23-25 CRESCENT STREET

APPLICATION FOR PERMIT
DEPARTMENT OF BUILDING INSPECTIONS SERVICES
ELECTRICAL INSTALLATIONS

AP 25 Crescent Street-I

To construct inside stairway in rear of building, from third floor to second floor, as per plan.

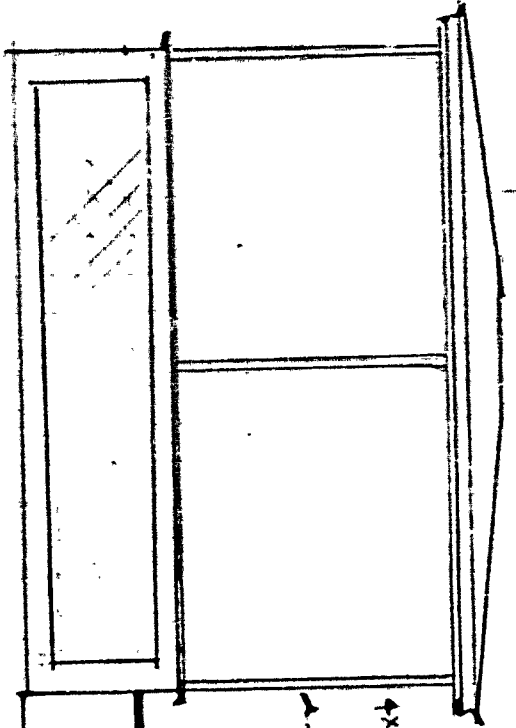
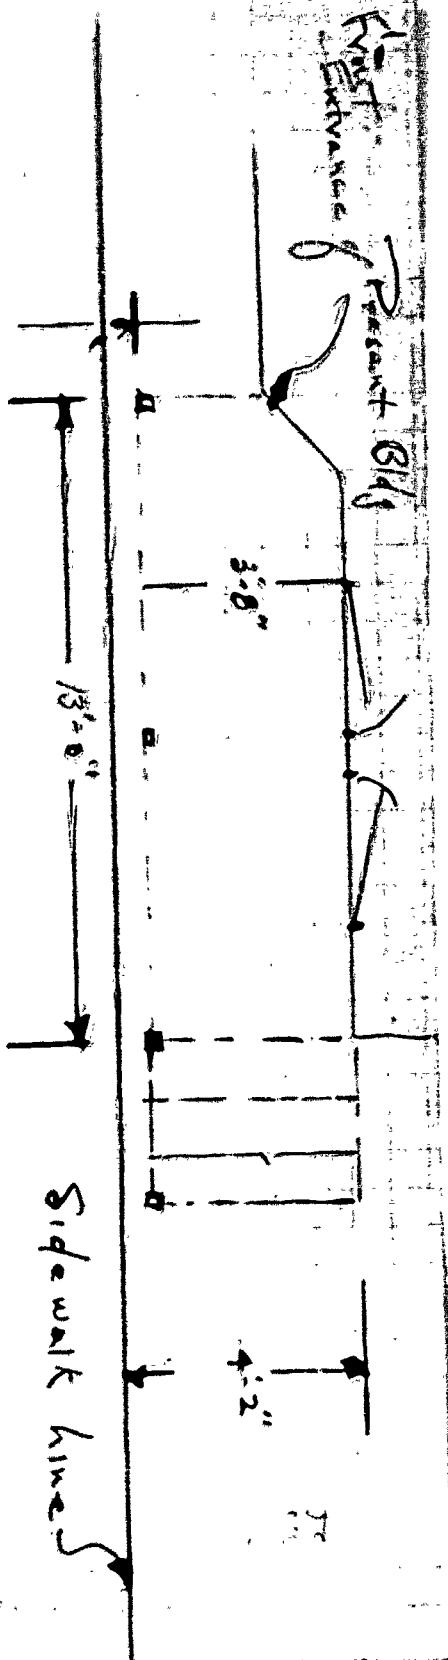
7/13/49 - Window not cut in and handrails have
not been provided in stairs. E.S.
8/25/49 - Handrails have not been provided, in
small window Permit been cut in E.S.
10/15/49 - Same E.S.
2/25/50 - Same T.D.
4-26-50. Mr. Beck said he would provide required handrail.
Opening has been cut in ceiling so that light from dormer
provides light for new rear stairs. E.S.
5-15-50. Handrails not provided. Mr. Beck said owner
plans on doing work himself. E.S.
5-16-50. Mrs. Marchant said they would do this in the
next two weeks. E.S.
6/15/50 Same. No work done. (T.D. 10/11/50)
6-16-50. Mrs. Marchant said handrail will be on by June 30th
E.S.
6-30-50. Not done. E.S.
8-7-50. Mrs. Marchant has railing brackets in place
said railing will be up tomorrow. E.S.
